# CITY OF ALBUQUERQUE

May 16, 2018

RE: **Signal Village Subdivision**  
**Drainage Report**  
**Engineer's Stamp Date 5/10/2018**  
**Hydrology File: C20D078**

EXISTING XS

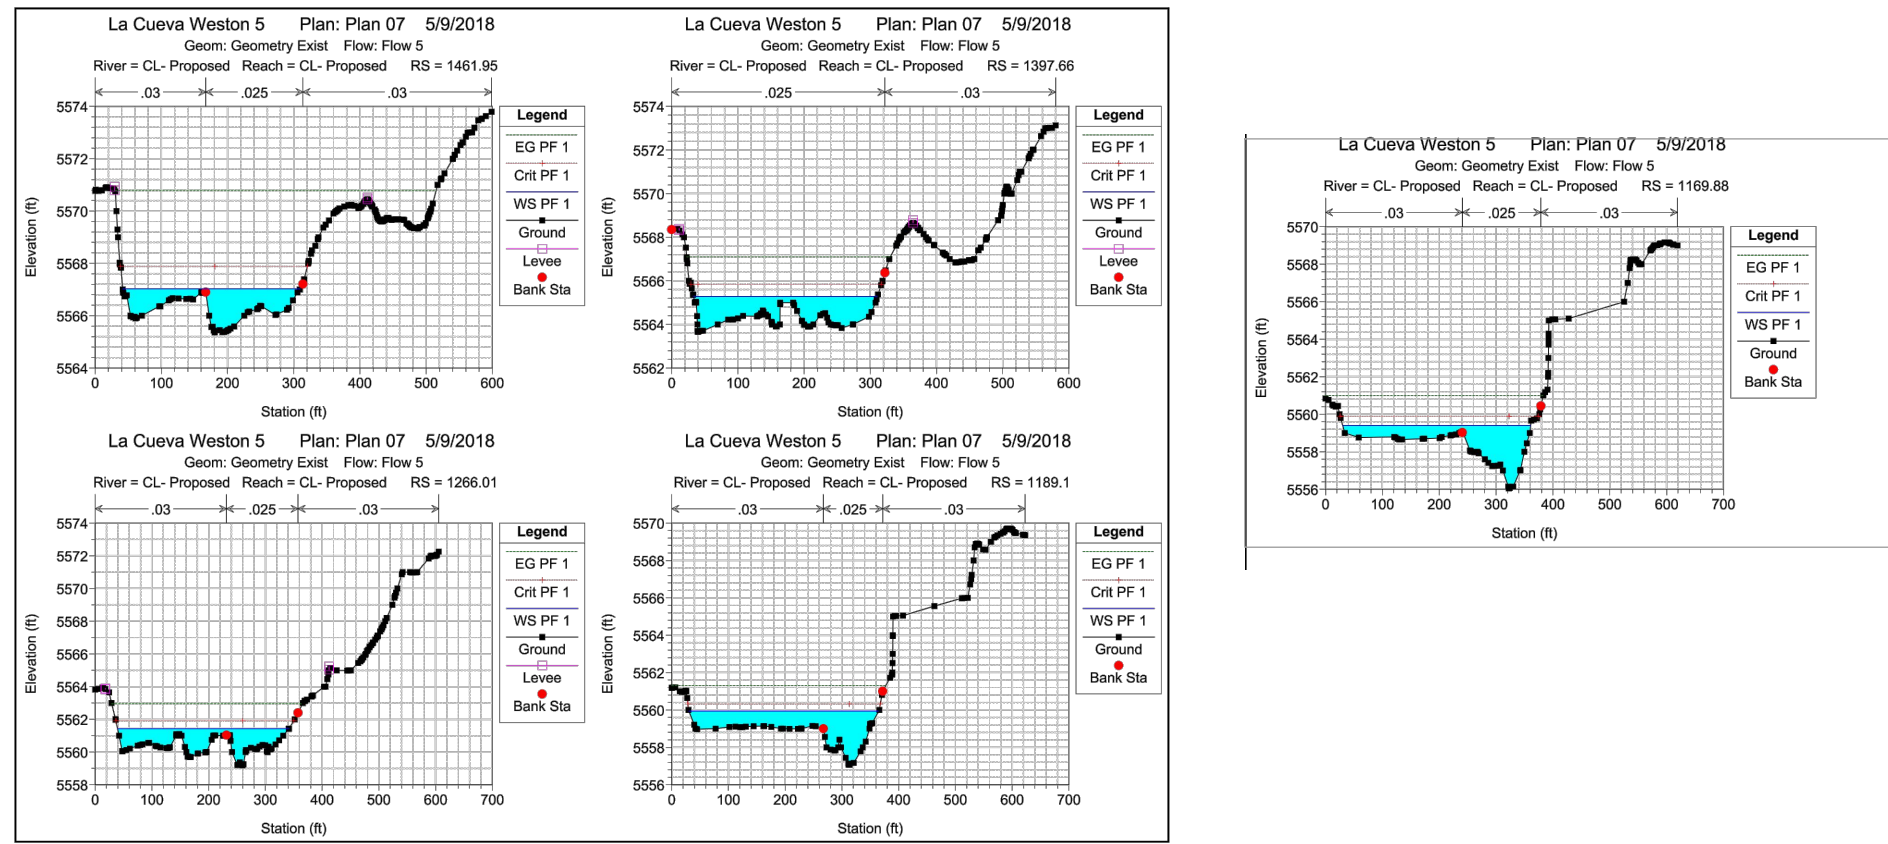
1. Supercritical flows are shown at nearly every cross section in the HEC-RAS model. Irregularities in natural arroyos generally prevent sustained supercritical flow so the model must be changed to subcritical only.
2. The model shows that the proposed fill in the floodplain will cause increased water surface elevations on neighboring properties. This may be allowed if the neighboring properties provide written permission for the specific maximum increase in Base Flood Elevation and Floodplain width associated with this project.

LA CUEVA ARROYO  
FLOODPLAIN ANALYSIS  
EXHIBIT A

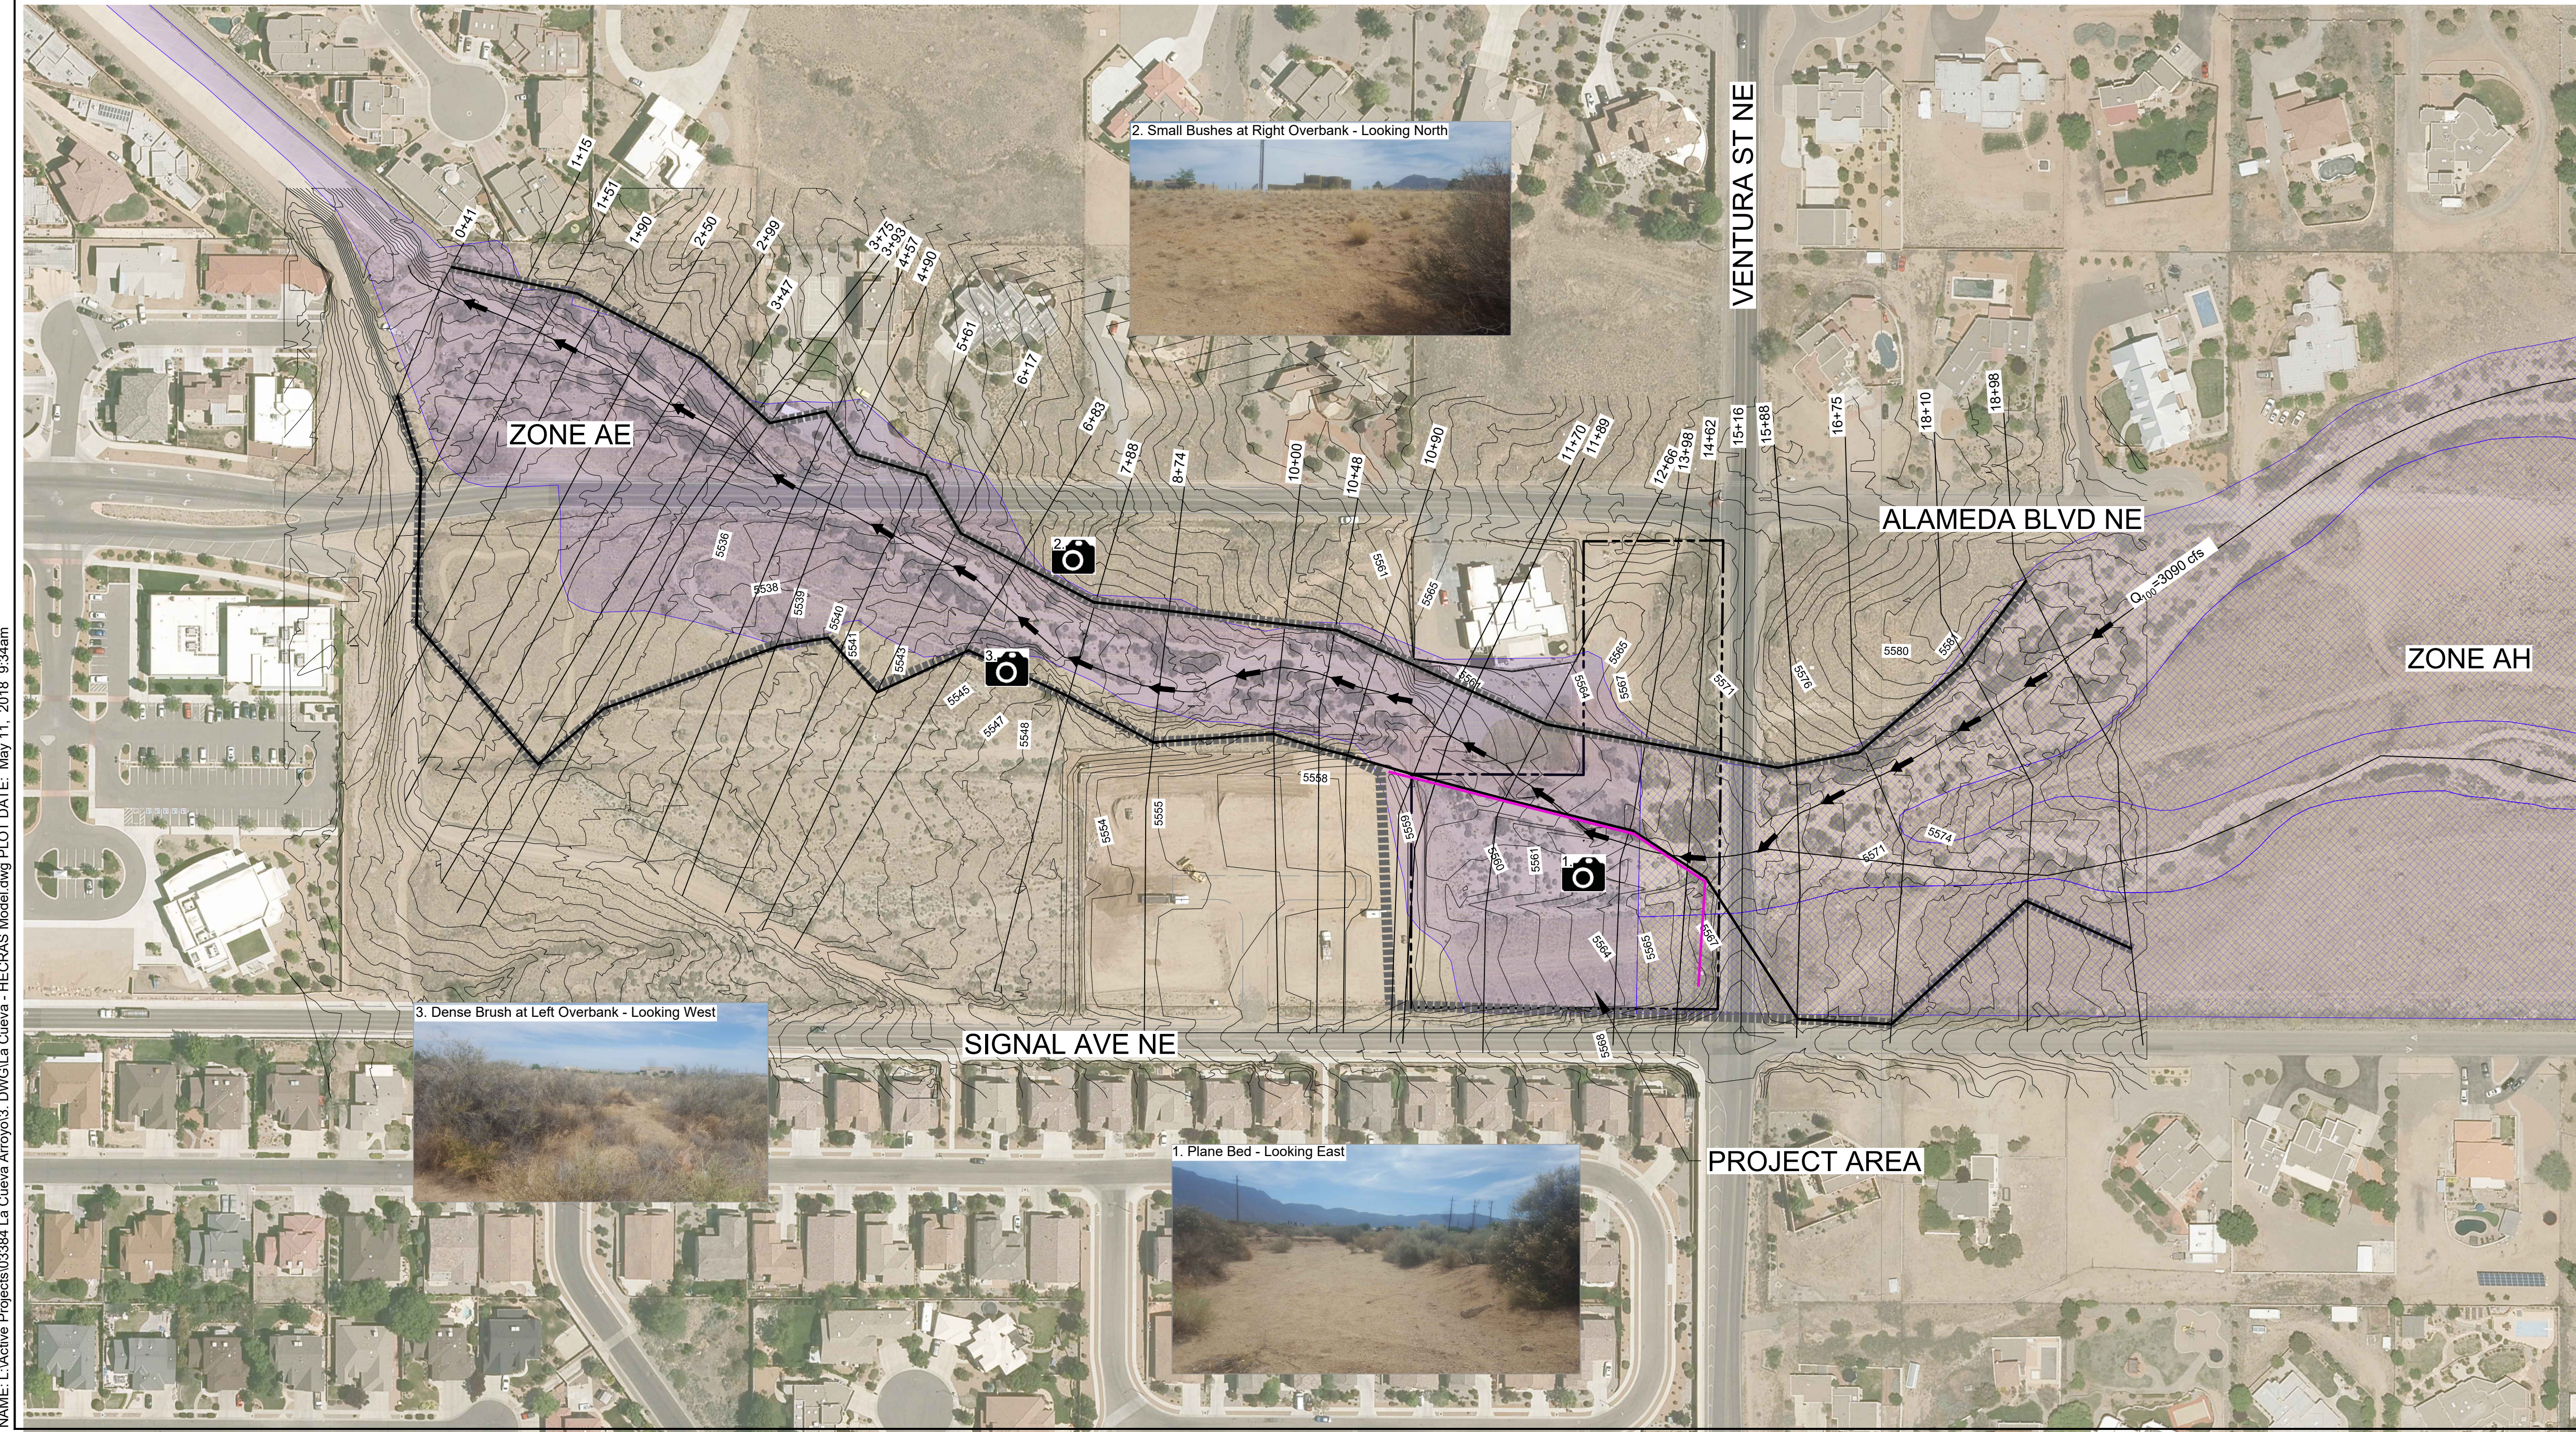
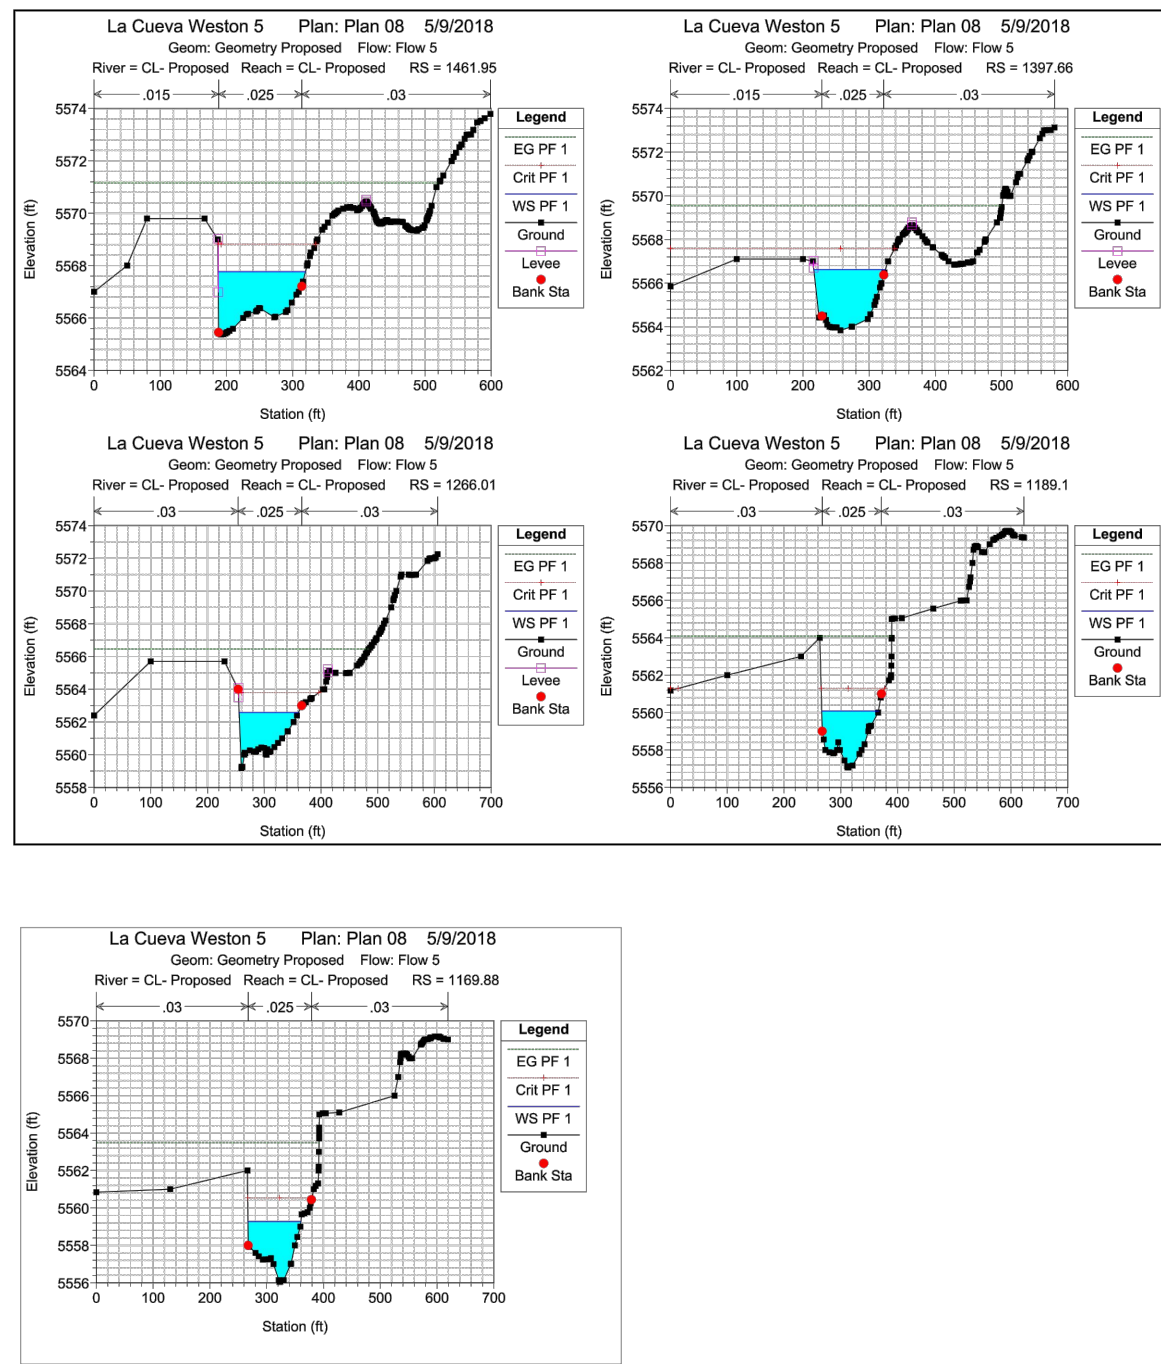
3. It is unclear what condition has been modeled on the lot at 9000 Alameda Blvd. where the owner has placed obstructions in the arroyo and is currently working on a plan to resolve violations of the Flood Hazard and Drainage Control ordinance and Section 404 of the Clean Water Act. The report must specifically address what assumptions that are being used in the model of the Signal Village Subdivision. It is possible that cooperation between the two projects may yield a mutually beneficial solution, but that solution must address both the floodplain and the 404 issues. A joint project will have to include restoration of an unobstructed sand bottom channel that preserves sediment continuity through the project area. A joint project will also have to include Agreement and Covenants and a Public Drainage Easements for the floodplain and the scour protection on all developed lots. Permission for increased BFEs will be required from all affected properties including any not being developed at this time.
